Chaco 2306-19E #189H

ADMINISTRATIVE APPLICATION CHECKLIST 30-043-21188

Re: Request for Administrative Approval of a 200-acre non-standard project area in the Lybrook Gallup Oil Pool (42289) and for non-standard location for the Chaco 2306-19E #189H, API: 30-043-21188

WELL LOCATION AND ACREAGE DEDICATION PLAT

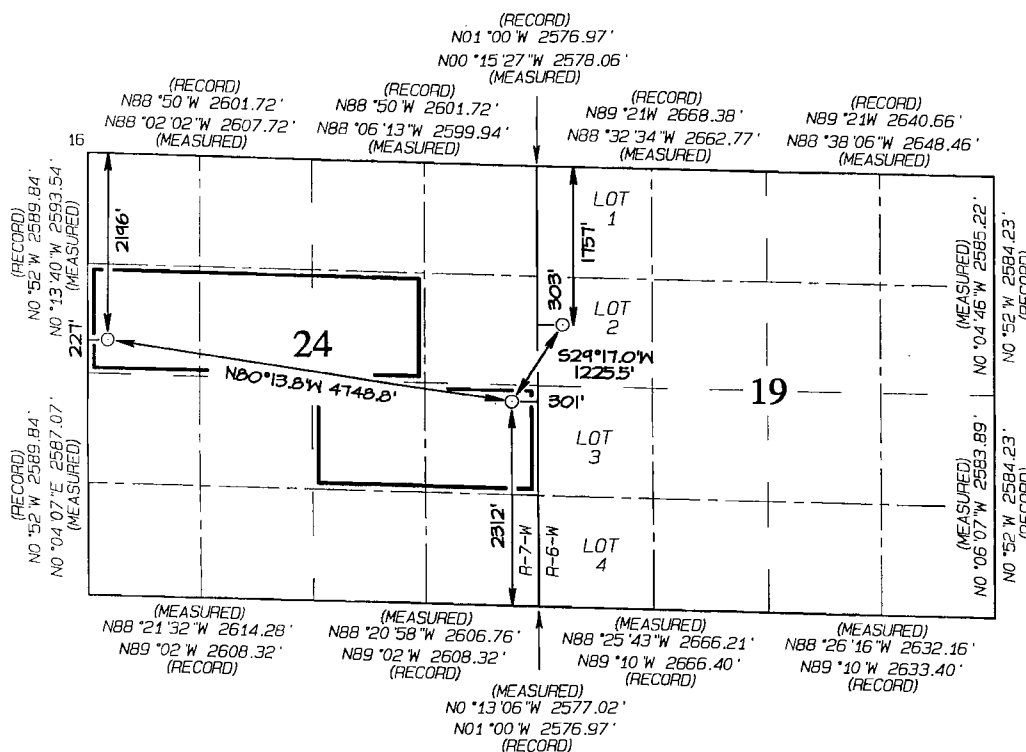
Can you sign and e-mail me C102's for the 188H and 189H? The C-102 has the survey signed, but not company representative.

I'm sorry Michael. We sign the official "As Drilled" C-102s and they are already on record with the OCD. I thought that the copies I send in my NSL application are just courtesy copies not requiring signatures. I will get these to you.

Ms. Riley
IF they are as-drilled, then no signature is required.
How is the letter going for the allowables we discussed today?
Michael McMillan
